# **West Wallsend Colliery Continued Operations Project Response to Submissions**

November 2010

Project Director:	Barbara Crossley
Project Manager:	Kirsty Davies
Report No.	2553/R13/Final

FIGURE 2.2

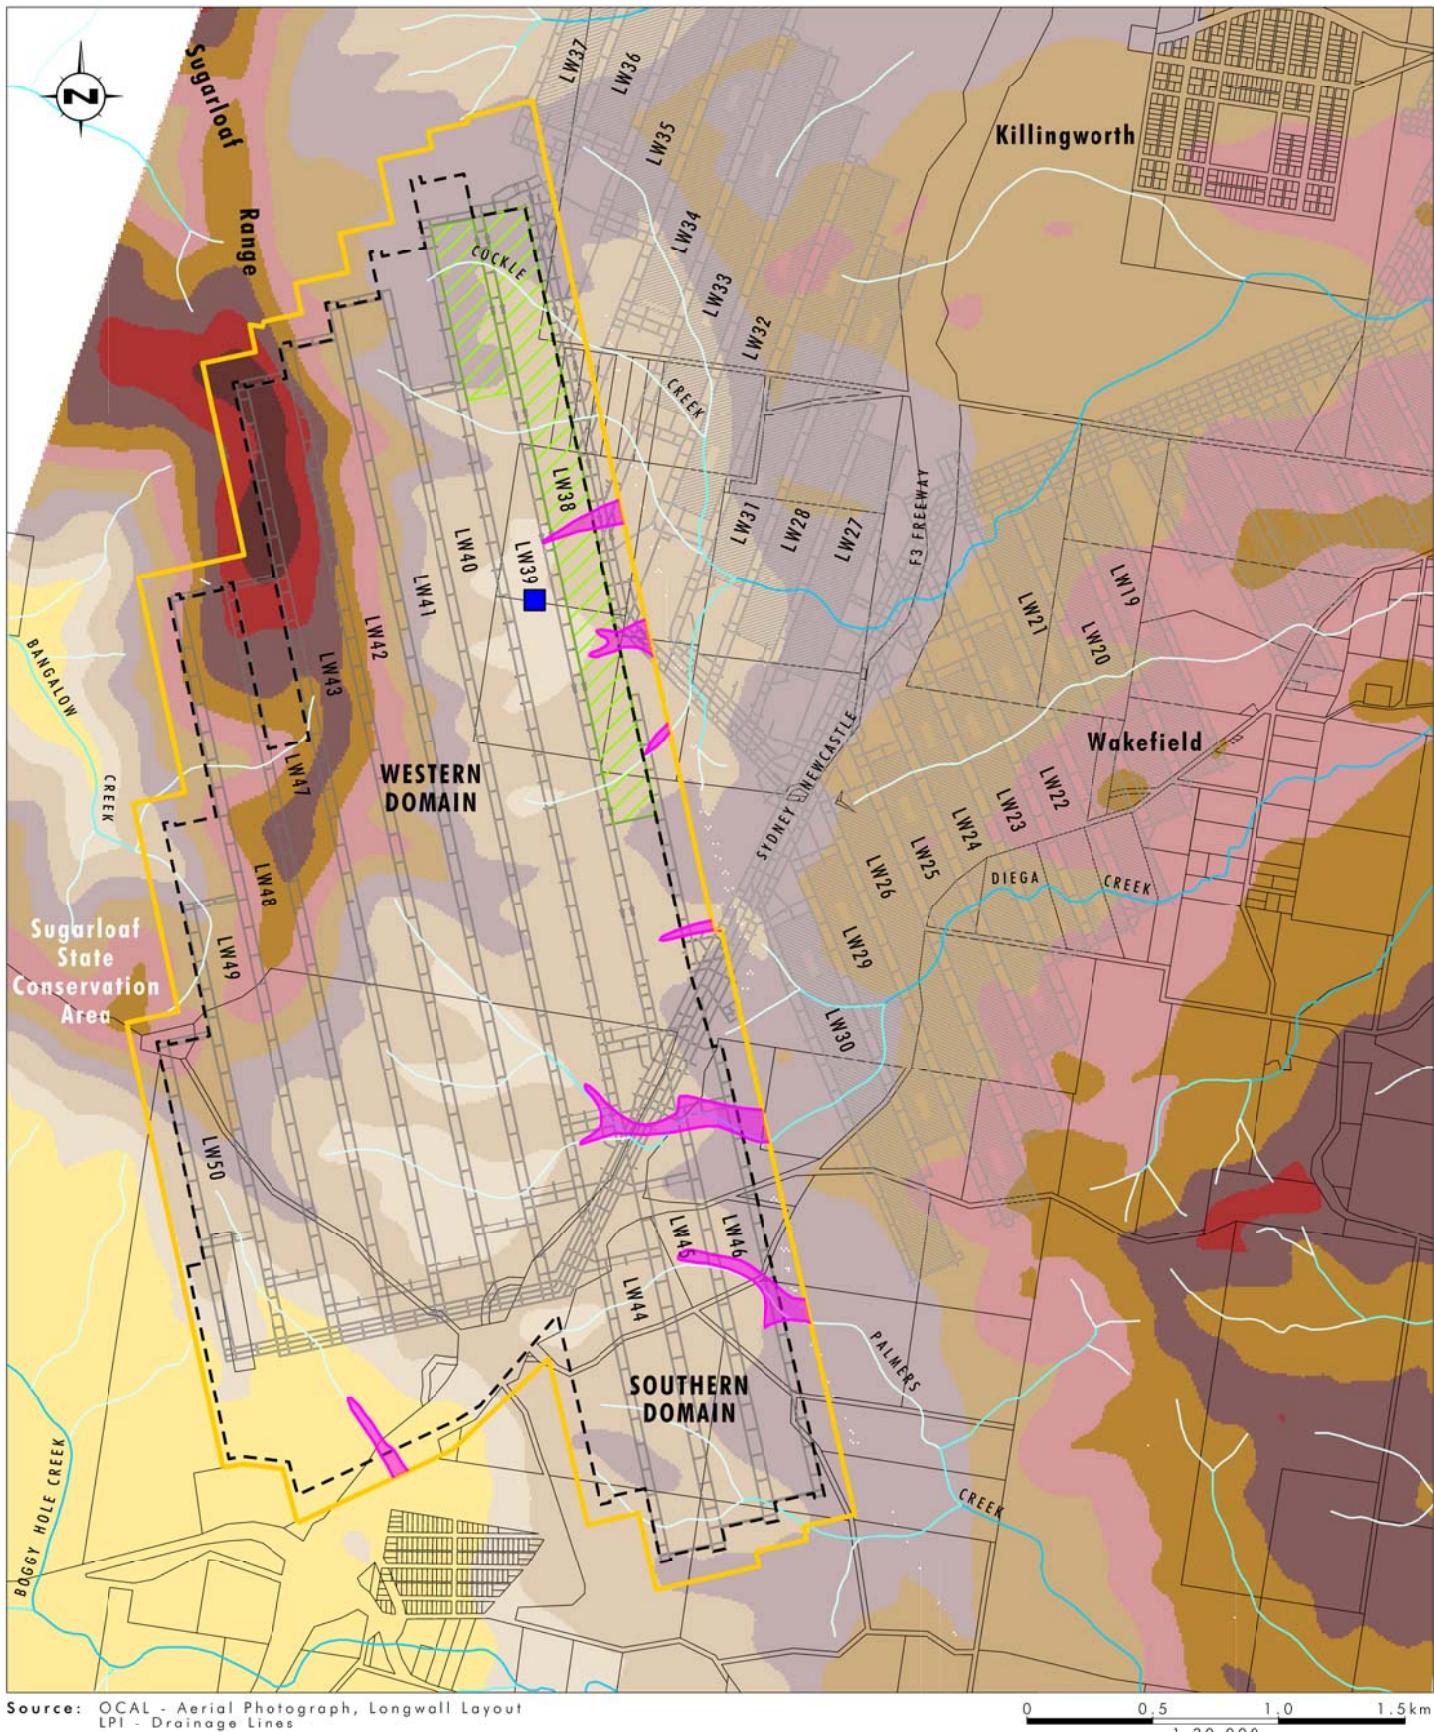
**Any alluvial aquifers and/or watercourses located in areas where the depth of cover is less than the critical limits for hydraulic connection need to be identified and assessed in consultation with the Office of Water.**

There are no alluvial aquifers present in the areas with a depth of cover less than 100 metres within the continued underground mining area, refer to **Figure 2.2**.

**Figure 2.2** shows the range of depth of cover throughout the continued underground mining area. Significant modification to the mine plan has been undertaken to avoid areas of low depth of cover (i.e. <70 metres). No longwall mining operations are proposed to be undertaken below 70 metres depth of cover.

There are no watercourses within the continued underground mining area proposed to be undermined with a depth of cover less than 70 metres (refer to **Figure 2.2**).

**FIGURE 2.4**

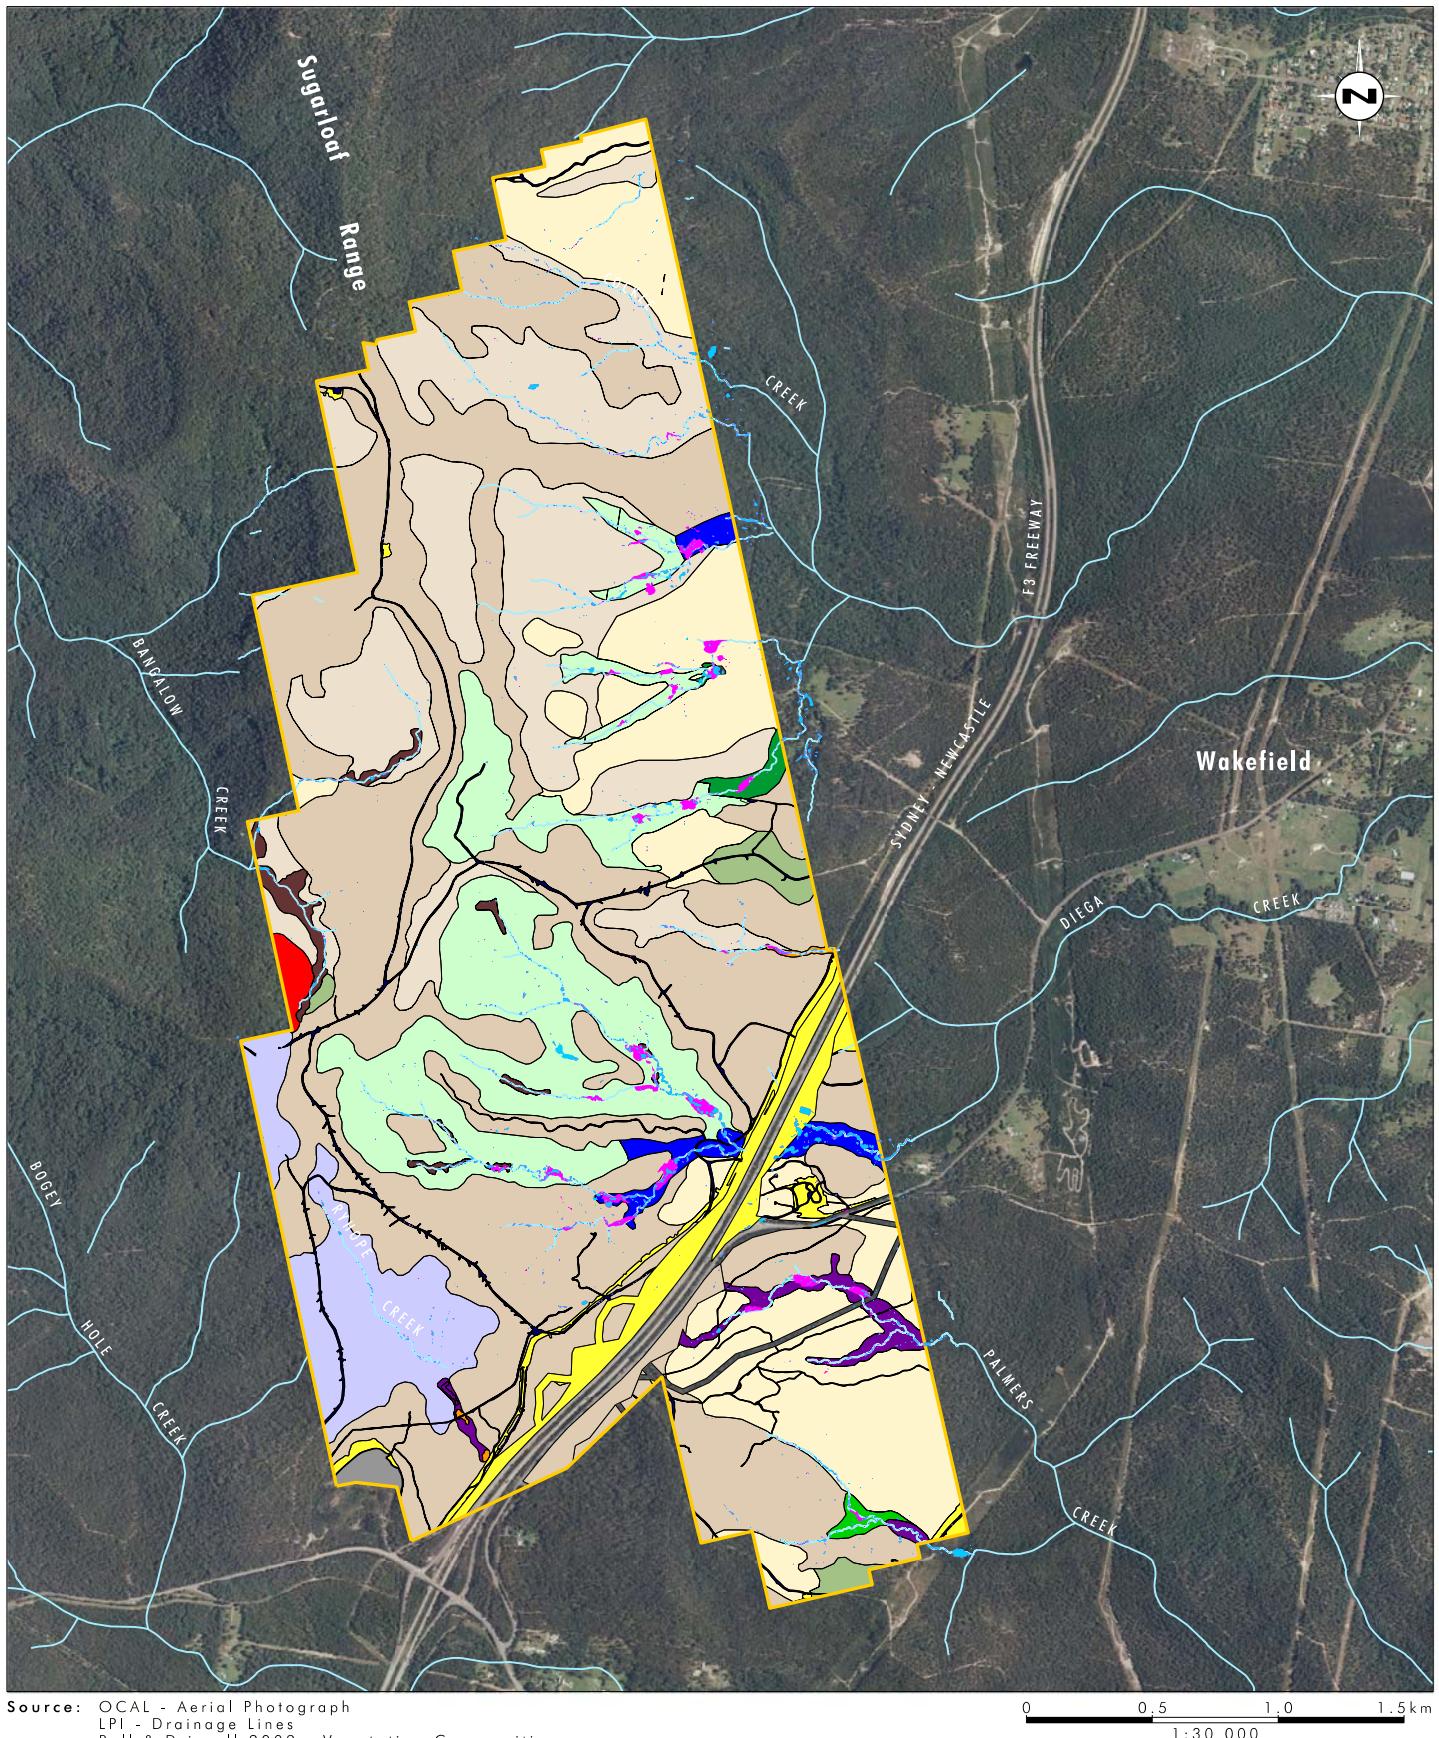
**DECCW requests that the proponent clearly describes the actual (maximum) loss of vegetation predicted for the project and clearly specifies where, and what, vegetation types/habitats will be removed and/or adversely affected.**

Assessment of vegetation communities to be impacted has concluded that approximately 1.8 hectares of Alluvial Tall Moist Forest EEC occurs within the predicted surface water ponding impact zone (refer to **Figure 2.4**), as well as 0.45 hectares of Swamp Mahogany Paperbark Forest. These communities are not expected to be significantly impacted however, as the community is adapted to 'wet' conditions and the ponding is expected to be of short duration only due to natural seepage and evaporation.

An assessment of the impact of ponding in vegetation communities has concluded that approximately 1.8 hectares of Alluvial Tall Moist Forest EEC occurs within the surface water ponding impact zone and approximately 0.45 hectares Swamp Mahogany Paperbark Forest (refer to **Figure 2.4**).
